St. Bernard Behavioral Health Center

St Bernard MHSD

A D D E N D U M

Addendum Letter: D
Project Number: 1849
Date of Issuance: 04 November 2019

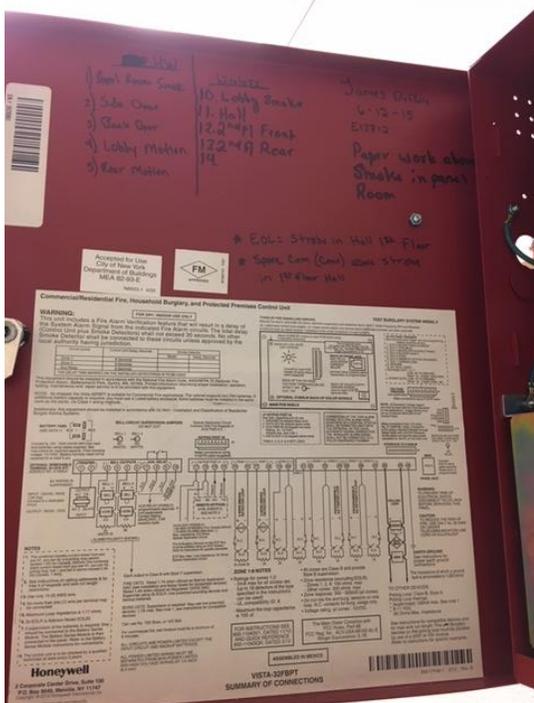
Question: 1. Please provide information on the existing fire alarm manufacturer/service provider.

Response: See images below”
